ARM Group Inc.

Re: Phase II Investigation Work Plan
Area A: Parcel A18 (Revision 0)
Comment Response Letter
Tradepoint Atlantic
Sparrows Point, MD 21219

Parcel A18: Proposed Boring Locations Aerial View November 15, 2019		Figure 4
 Source: Esri, DigitalGlobe, GeoEye	 ARM Group Inc. Engineers and Scientists	
	Tradepoint Atlantic Baltimore County, MD	
	EnviroAnalytics Group	
	ARM Project 150298M-20

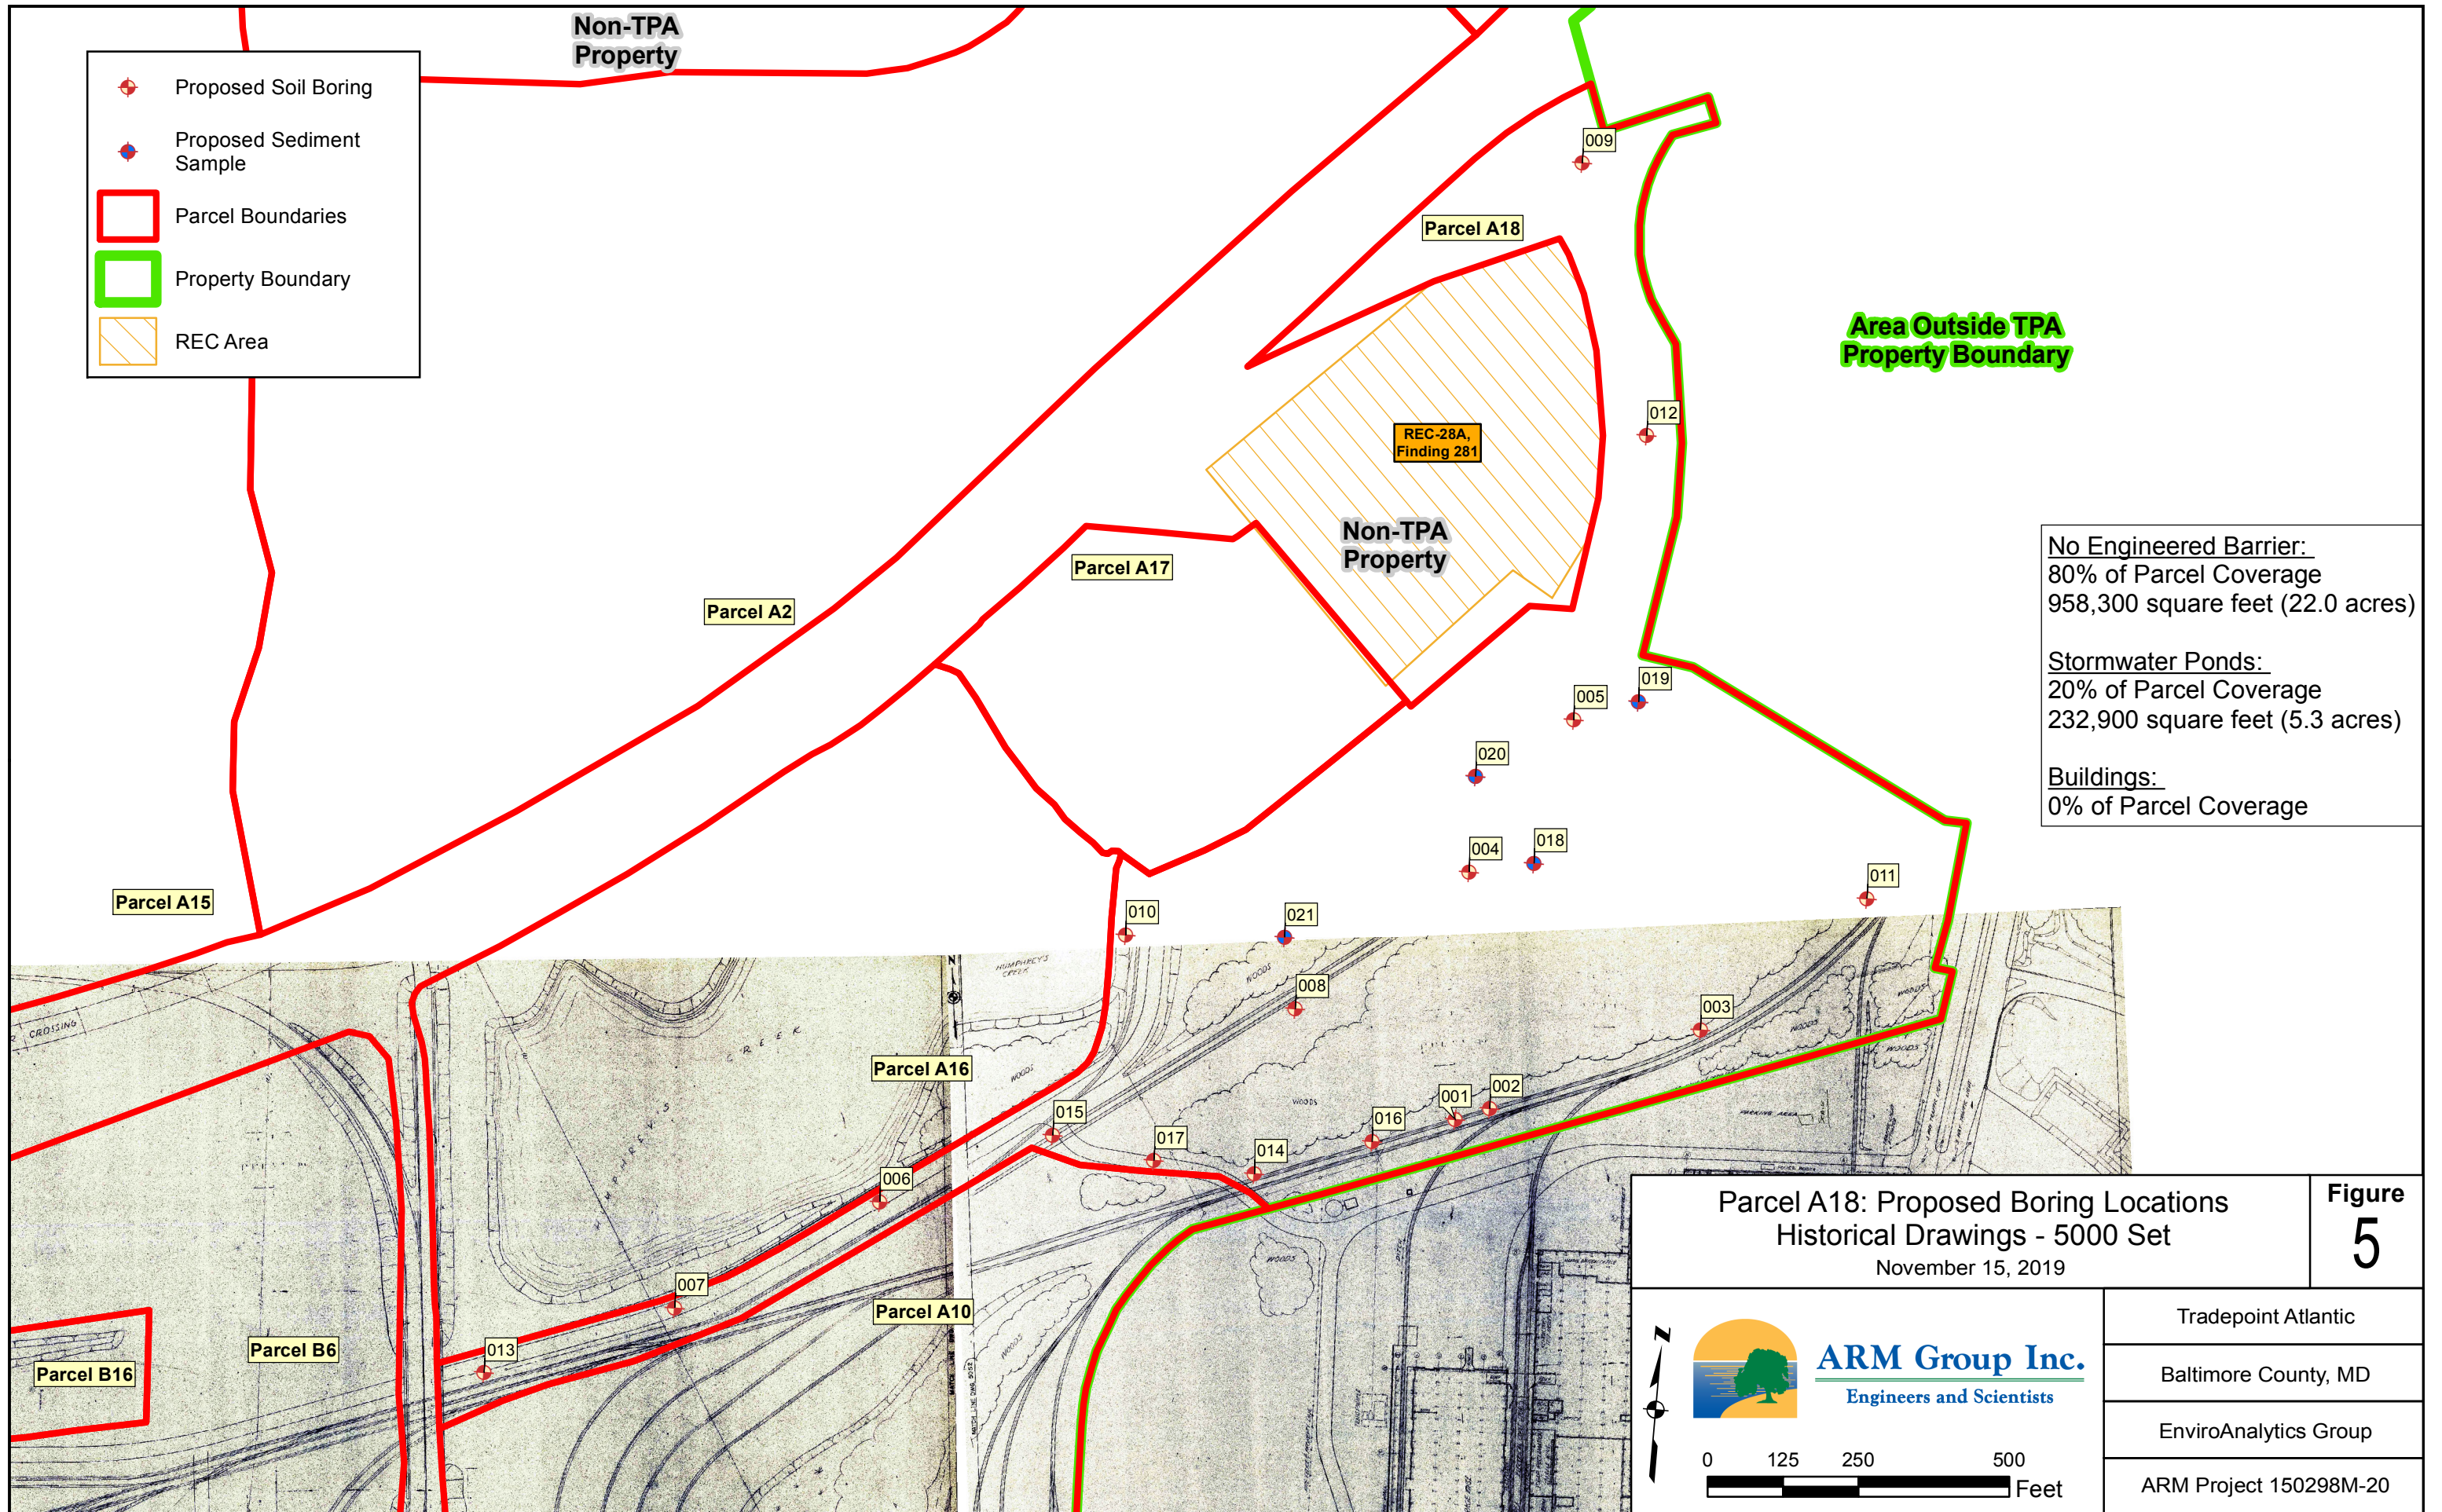
3. *Add two additional groundwater sampling points in the area near A18-014 and A18-015 to investigate concerns related to historical dumping and elevated CVOCs on the adjacent A10 property. Groundwater borings located between A18-014 and A18-015, then between A18-014 and A18-002 would be acceptable locations.*

3. *Sediment samples should be collected from this parcel, particularly due to access issues for a sizeable portion of the site.*

Two additional sample locations, A18-016 and A18-017, have been added to better assess the area of concern in the nearby A10 property. Soil and groundwater samples will be collected at each of these locations. The additional points are shown on the revised figures and have been added to the sampling plan table.

Sediment samples will be collected at four locations, two in each impoundment area. The approximate sediment sample locations are shown on the revised sampling plan figures. These locations may be adjusted in the field due to access restrictions and steep slopes. The sediment samples will characterize the accumulated sediment where Geoprobe® access will likely be infeasible due to standing water or wet ground conditions. Each of the sediment samples will be collected as a grab sample from the top 12 inches of sediment. The sediment sample locations appear at the edge of standing water as shown on the revised work plan figures.

Parcel A18: Proposed Groundwater Sample Locations - Aerial View November 15, 2019		Figure 9
 ARM Group Inc. Engineers and Scientists	Tradepoint Atlantic	
	Baltimore County, MD	
	EnviroAnalytics Group	
	ARM Project 150298M-20

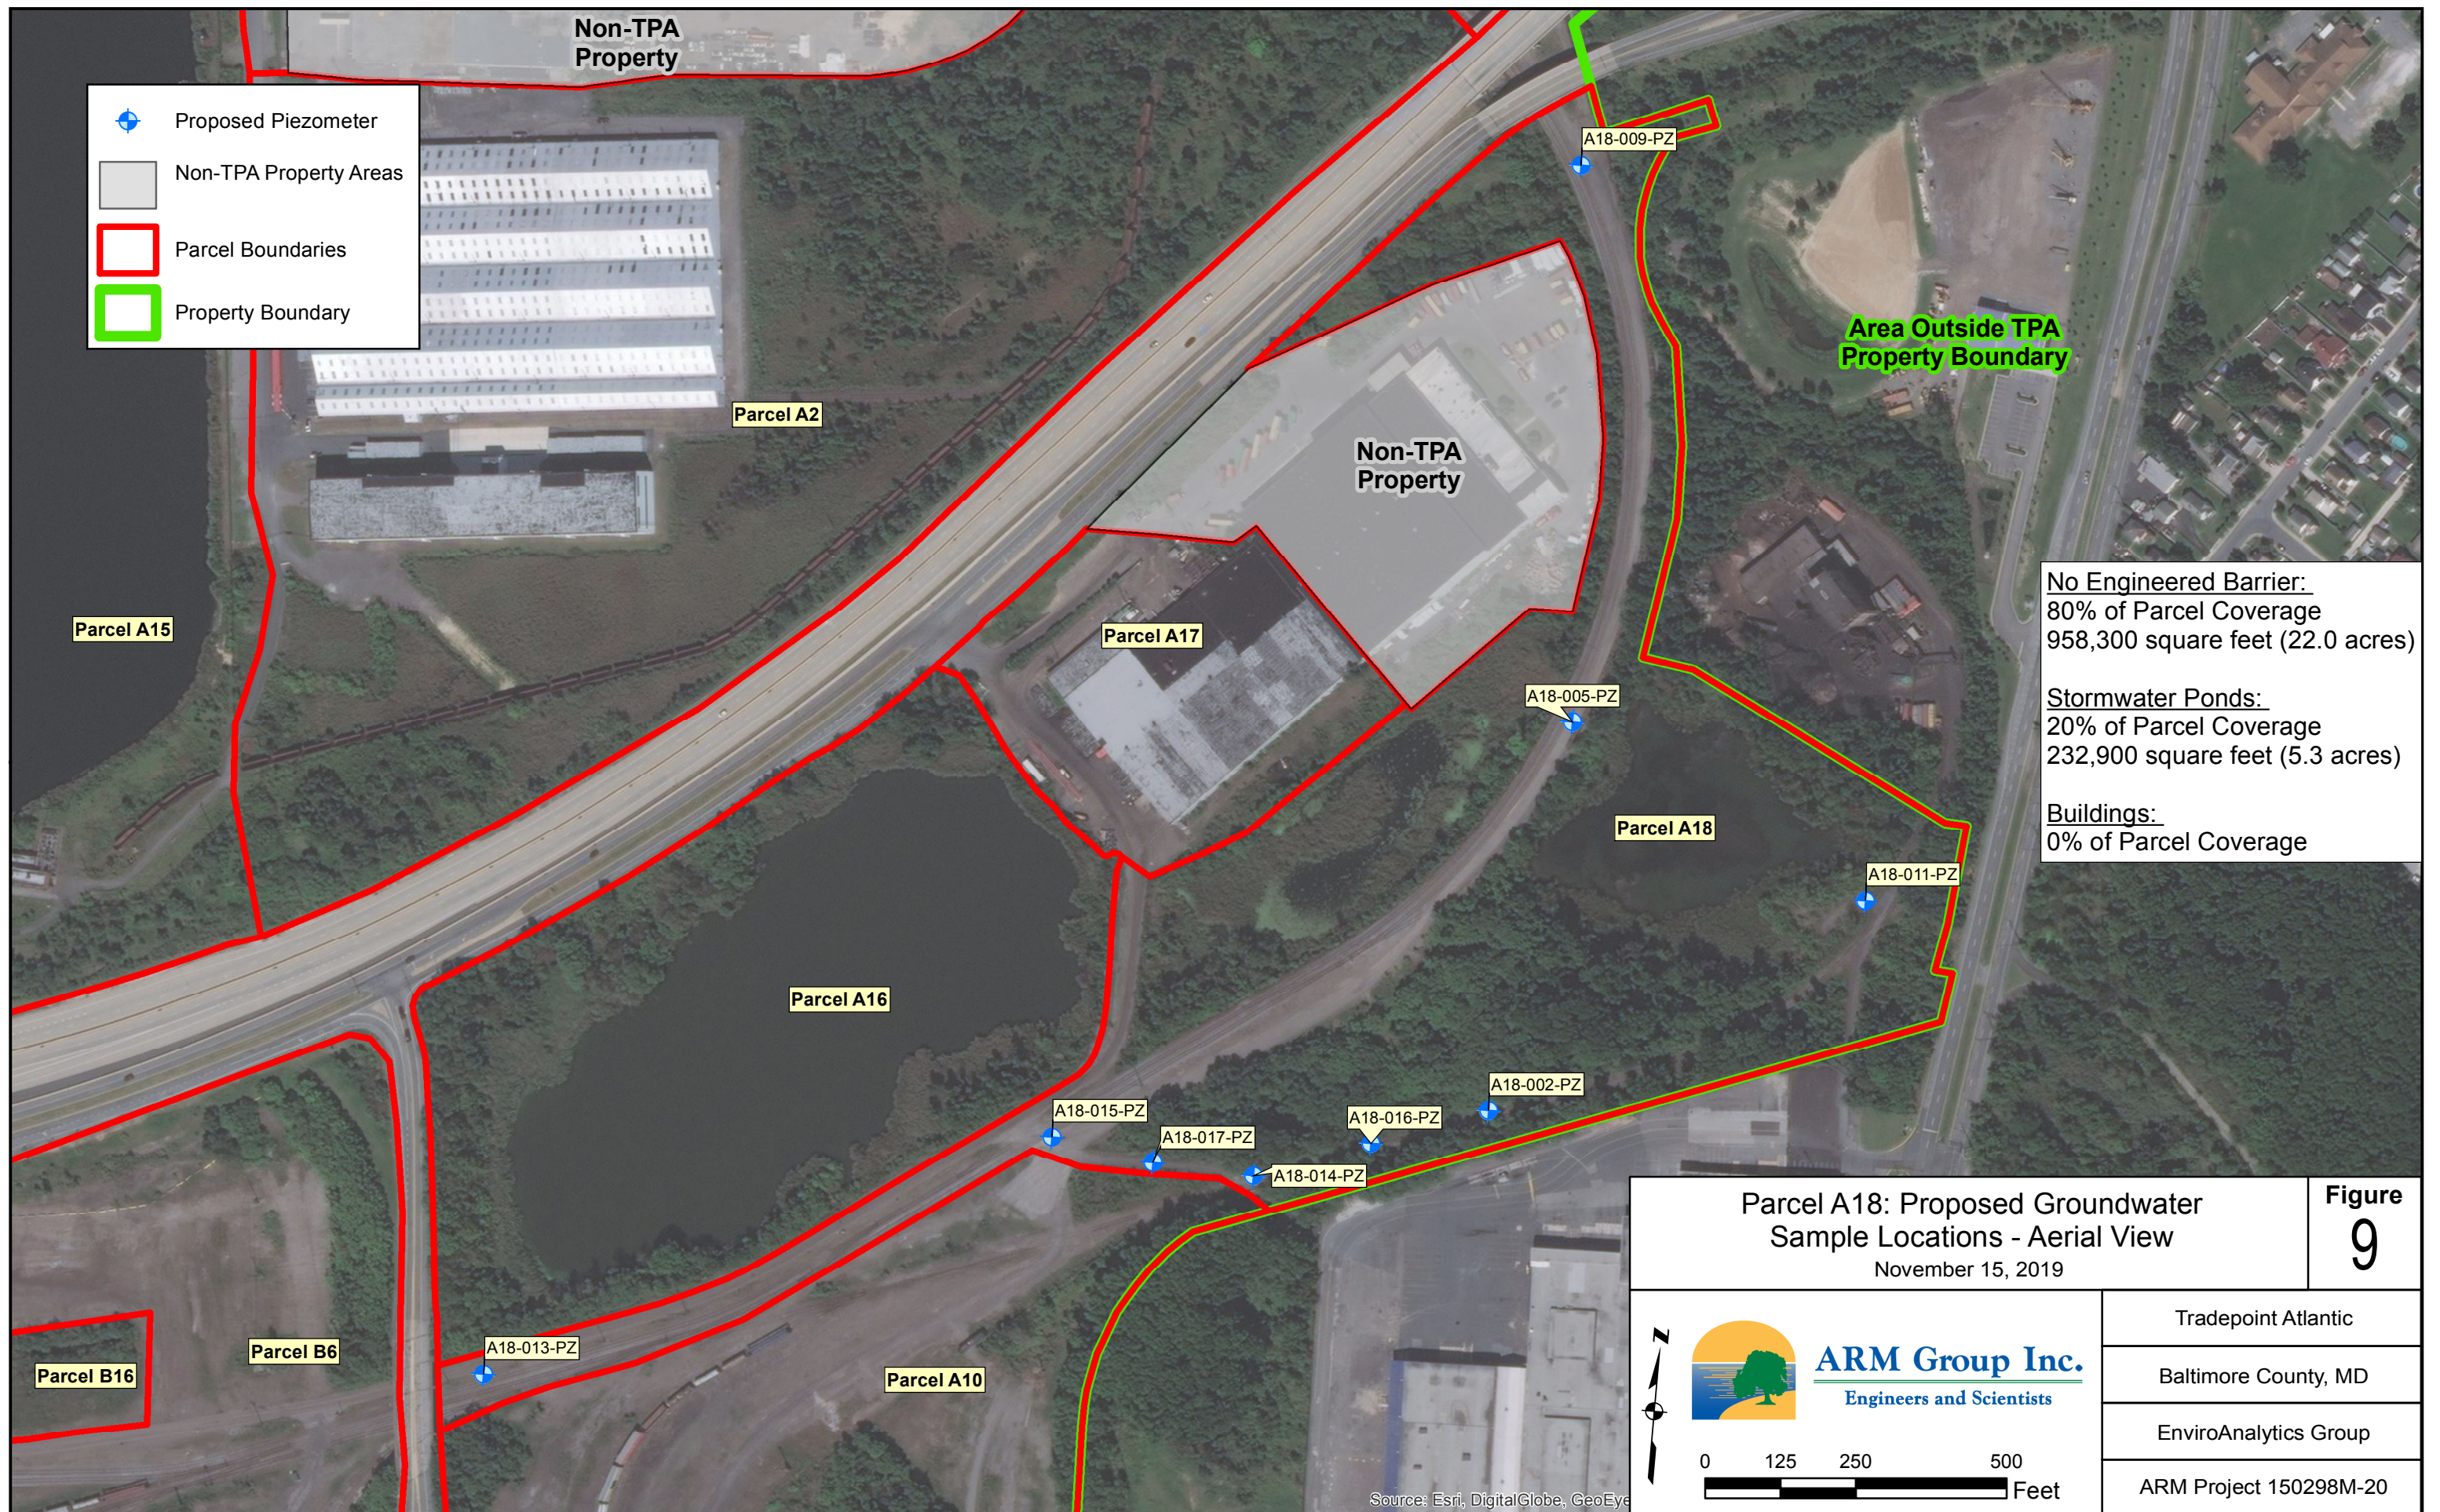
2. *The land around A18-009-SB, outside of the rail lines, was observed to be significantly sloped and wooded. So no additional borings are required in this area*

and the location of A18-009-SB can remain as proposed in the Work Plan. Do add a groundwater sample to this boring location.

A piezometer will be installed, and a groundwater sample will be collected from the originally proposed location of A18-009.
